PERMISSIVE CHANGE LETTER

This **permissive change letter** concerns the approval OQA-A08LA0AM for the model A08.

Changes/Differences for Model A08

Please find here below the photos of the current and new AIRTR08LM.

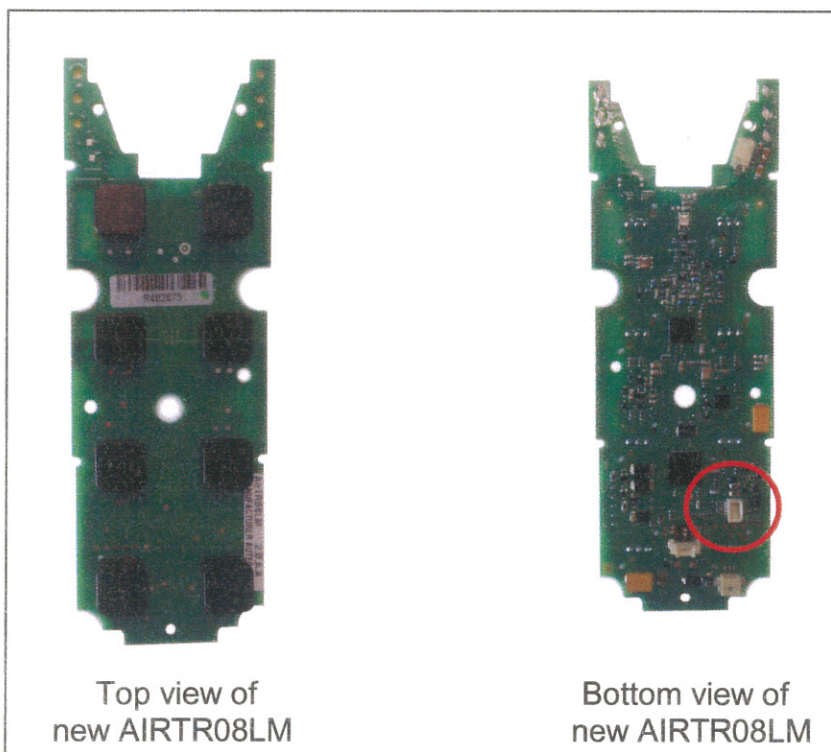
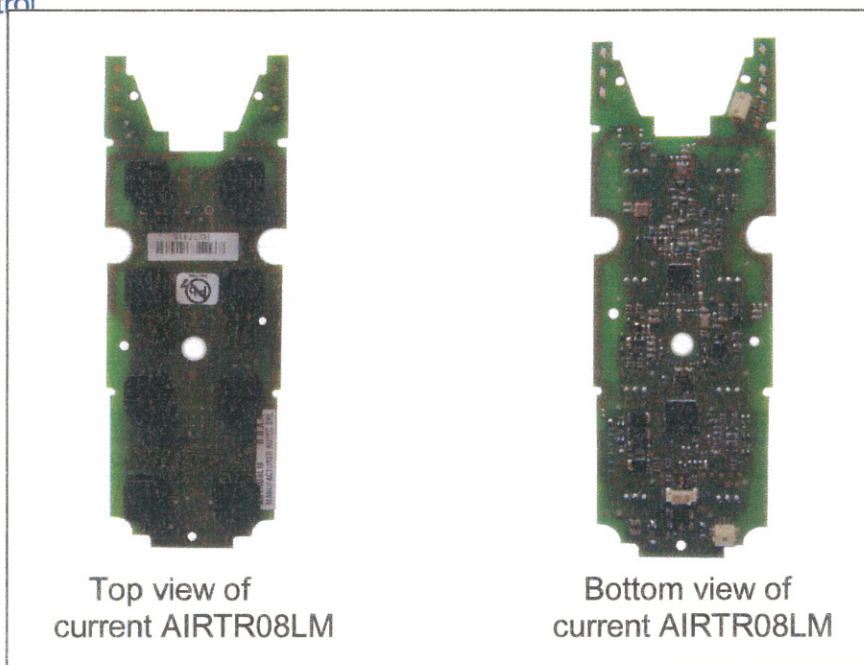
The change is on the AIRTR08LM radio keypad.

The current AIRTR08LM has schematic diagram SC000370.

The new AIRTR08LM has the schematic diagram SC000451 (please see the file "sch_SC000451_airtr08lm.pdf").

As shown by the photos, the main difference is the presence on the bottom of radio keypad of a connector where it can be fixed an address key AIRCHT04A (please see the schematic diagram "sch_aircht04a.pdf").

In the new AIRTR08LM radio keypad, the address key can be present or not in function of the application needs:

- when the address key is present, the unique and univocal address for the transmission radio is stored in a memory inside the address key
- when the address key is not present, the unique and univocal address for the transmission radio is stored in a memory inside the radio keypad
